Broadcast Products Technical Bulletin 20-2005-025

SUBJECT: **PROTECTOR PEELS OFF**

MODEL: **PDW-510
PDW-510P
PDW-530
PDW-530P**

Figure 1

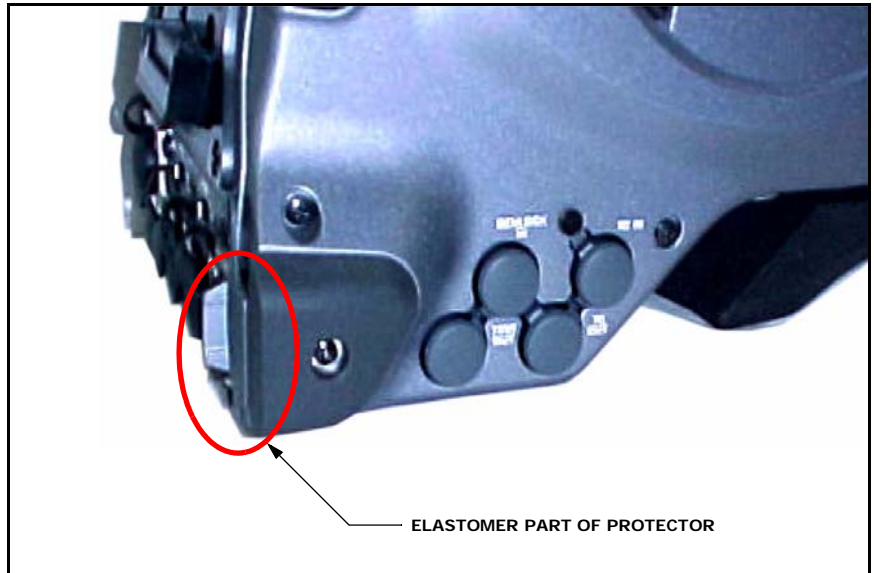
If the end of the protector is subjected to excessive physical stress, the elastomer part of the protector may peel away from the internal metal fixture. (See Figure 1.)
